## Technical Service Bulletin

20-01-028H

Elantra (AD/ADa)

ECU & TCU UPDATE AND IVT REPLACEMENT  
(SERVICE CAMPAIGN T5B)

### ECU, TCU Update Flow (AD/ADa with IVT)

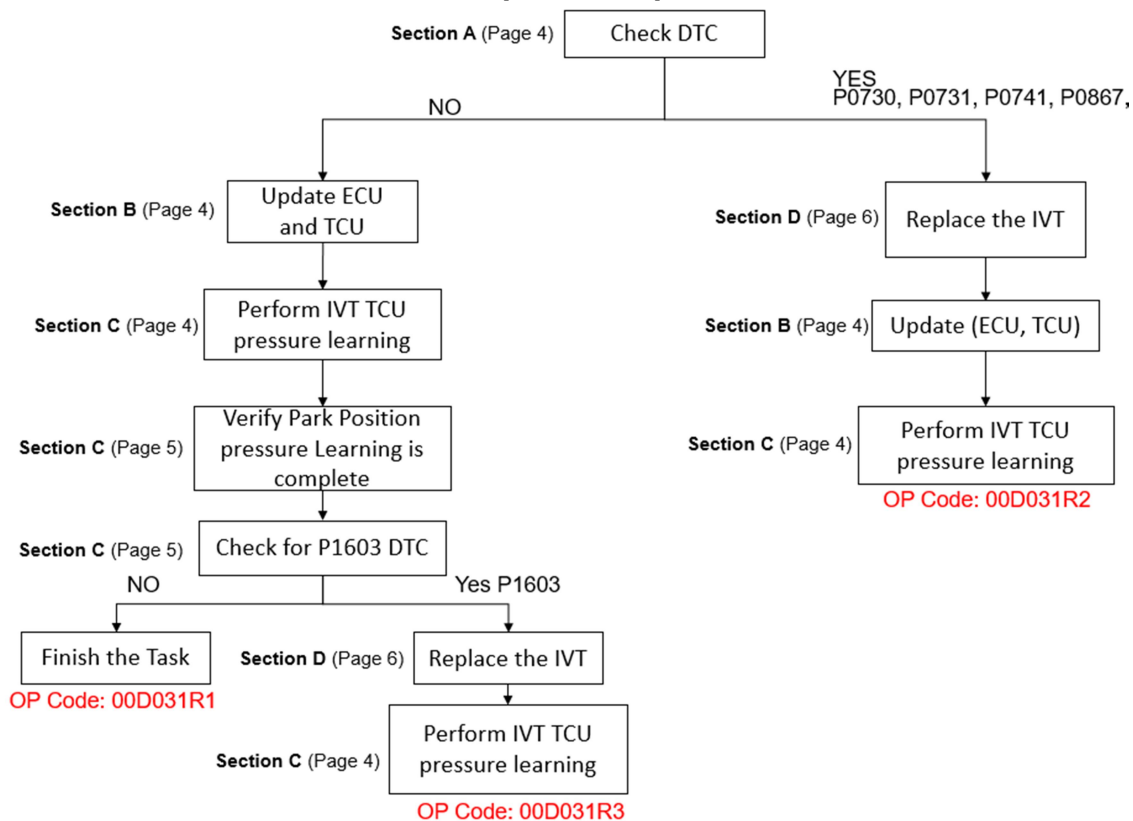
1. Use the GDS-M to check the TCU DTC.
2. If one of the DTC(s) P0730, P0731, P0741, P0867 applies (History, Current, or Pending), replace the IVT.
3. Replace the IVT according to the applicable vehicle shop manual.
4. After IVT replacement, perform ECU and TCU update first, then perform the IVT resetting auto T/A values, oil-pressure characteristics input, TCU adaptive values learning procedure.

IVT oil pressure characteristics label is located on the IVT bell housing.

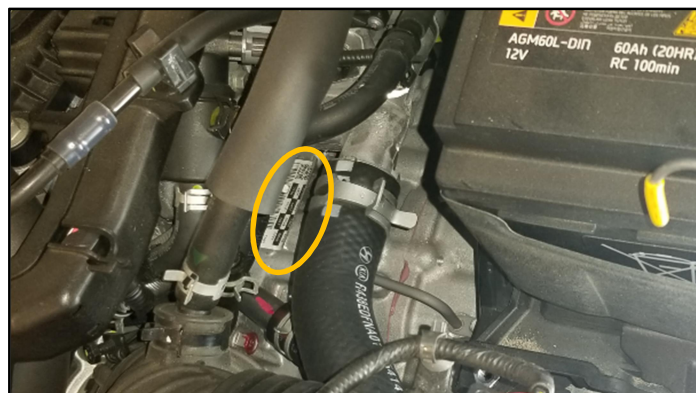
1. Perform IVT Resetting Auto T/A Values and Oil-pressure Characteristics Input procedures using the GDS-M.

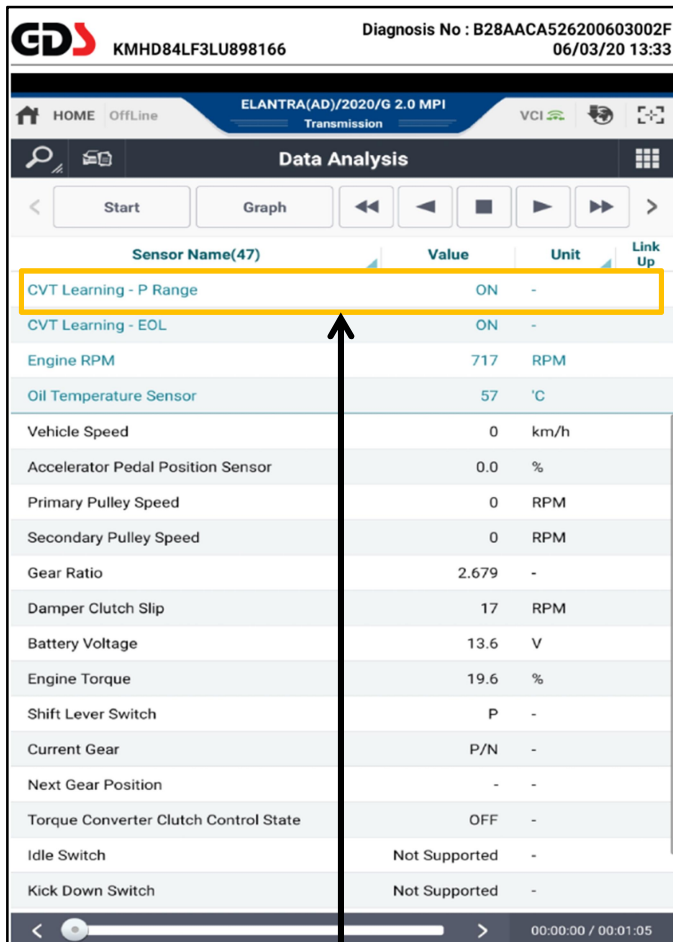
Use the GDS-M to verify the IVT P-Range learning is complete, and check TCU for DTC P1603 (EOL P-Range Pressure Learning Failed).

- (1) If IVT- P Range learning is not complete, and P1603 is present, Replace the IVT (Refer to **Section D.**)
- (2) If IVT-P Range is not complete, and P1603 is not present, the learning condition has not been met. Re-perform **Section C** - IVT, TCU Learning.

Learning completion can be confirmed by using GDS-M to verify the IVT ("CVT") P-Range learning value is "ON". ("OFF" learning has not been completed)
